MI ARCHITECT RESPOND TO
RRM DESIGN GROUP PEER REVIEW
COMMENTS

Memorandum

Date: May 20, 2025	
To: Brian Froelich, AICP	Organization: City of Capitola
From: RRM Design Group	Title: Design Review Team
Project Name: Capitola On-Call Architectural and Landscape Review	Project Number: 1783-10-PP24
Topic: 2178 41 st Avenue Review

West Elevation

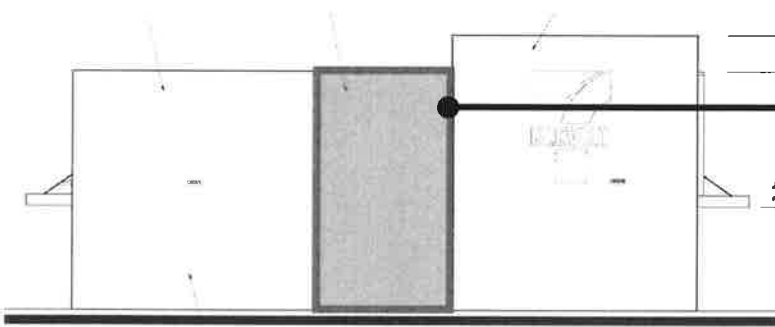
Building massing, or the way the building is sized and appears, is a primary and important component of building design. In review of the elevations provided on Sheet A2.1, the applicant has incorporated minimal massing strategies to remove the current “box-like” appearance of the proposed structure. The west elevation provides variation in massing through a change in wall plane height and the applicant may consider a similar strategy on the east elevation facing single-family residential uses to further improve the projects appearance to neighboring dwelling units (CMC 17.120.070 B). Additionally, the applicant may consider furring-out wall planes more than 6 inches when transitioning materials to ensure all materials terminate at-inside corners and further break-up the proposed structure on all elevations (CMC 17.120.070 H).

Explore projecting wall planes more than 6 inches when transitioning between materials to ensure material transitions occur at inside corners to remove a tacked on appearance and further break up the proposed structure.

*ADDED WALL PROJECTION, SEE REVISED FLOOR PLAN A1.1 & EXTERIOR ELEVATION A2.1

South Elevation

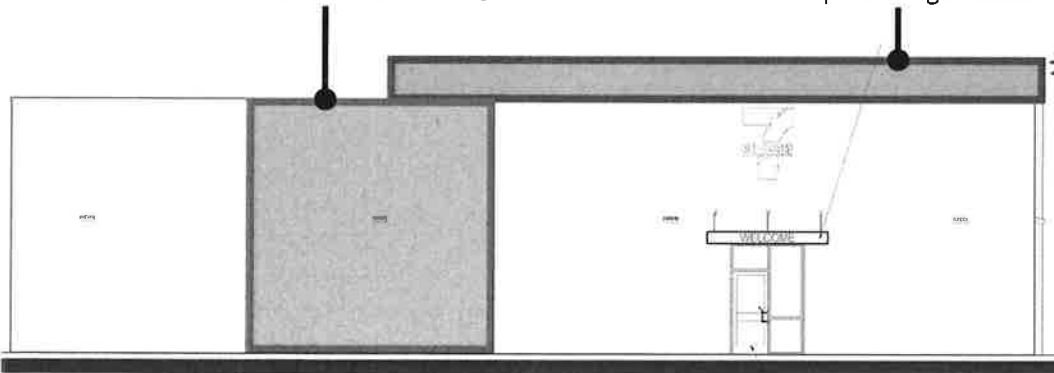
Incorporate an additional color or material on the east elevation to further articulate the elevation and improve the view for adjacent single-family dwellings.

Reduce the “box-like” appearance through the addition of a change in wall plane height on the east elevation, similar to the change in wall plane height shown on the west elevation.

*CHANGED WALL PLANE, BROKEN BY MATERIAL TO REDUCE THE BOX-LIKE APPEARANCE SEE SHT A2.1

East Elevation

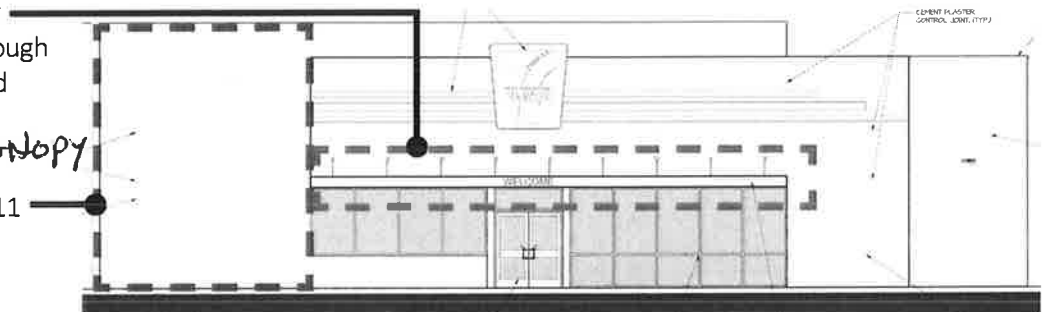
Articulation represents change in the form of a building expressed through proportion, details, wall plane changes, heights, and other design elements. The applicant has adequately articulated the west elevation of the proposed structure through the application of differentiation in colors and materials and incorporation of a stylistically consistent awning defining the primary entry. However, the applicant should explore opportunities to carry the articulation strategies onto the east elevation to remove the blank wall appearance facing the single-family dwellings (CMC 17.120.070 J).

Roof forms are critical elements in providing visual interest within a project and reinforcing architectural style. The applicant is proposing to use a flat roof style with 3'-3" parapet to introduce variation in the roof line appearance, generally considered consistent with the proposed architectural style. To establish a sense of variation along the east elevation roof line, the applicant may consider incorporating parapet, similar to the usage on the west elevation, to break up the current monotonous appearance of the unbroken roof line.

Example of Alternative Placement of 7/11 Sign to Enhance the Overall Elevation with a Stylistic Design.

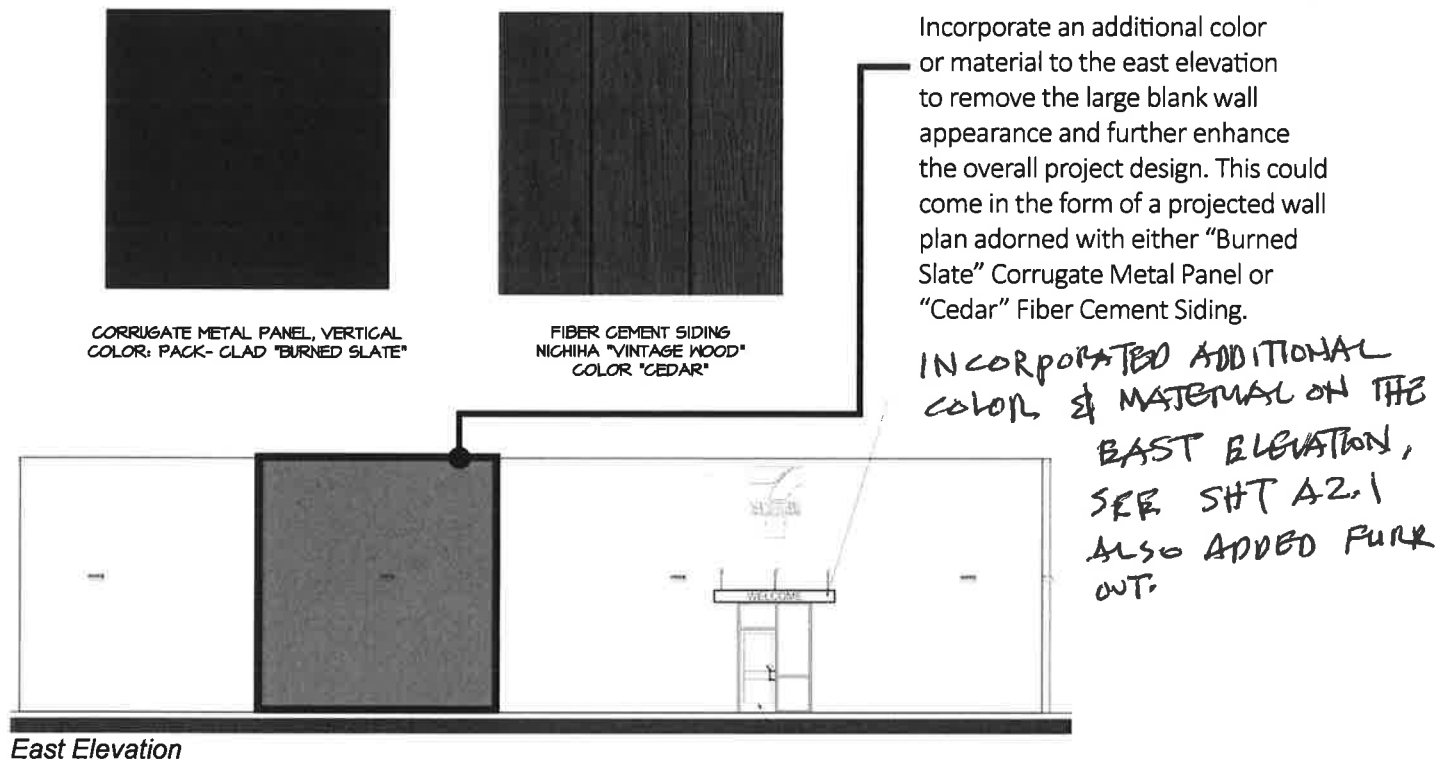
A primary entry contributes to the overall identity of a building by defining the architectural style and engaging with the public realm. The primary entry is provided on the street facing west elevation, defined by a covered awning and surrounded by large transparent windows. While the applicant has begun to define the primary entry, the project design could benefit from further accentuation of the canopy through enlargement or further incorporation of the canopy into the proposed signage, similar to the design interventions shown on 7/11's reflecting the updated architectural corporate branding. Alternatively, the applicant may consider relocating and enlarging the 7/11 sign to the open space shown on the left side of the elevation to establish a connection with the public realm and improve the project design.

Further enhance the primary entry and west elevation through accentuation of the proposed canopy.

Windows and doors help define an architectural style and add visual interest to a buildings design. The applicant is proposing Clear Glass and Black Aluminum Storefront Doors and Black Aluminum Storefront windows, considered consistent with the proposed Contemporary architectural style. To further enhance the street facing west elevation, the applicant may explore the possibility of applying windows above the proposed awning to establish transparency and elevate the project design.

* ACCENTUATED THE CANOPY
SEE SHIT A2.1
Alternatively, relocate the 7/11 sign to enhance the overall elevation.

* ADDED CLEAR STOREY WINDOWS
SEE SHIT. A2.1
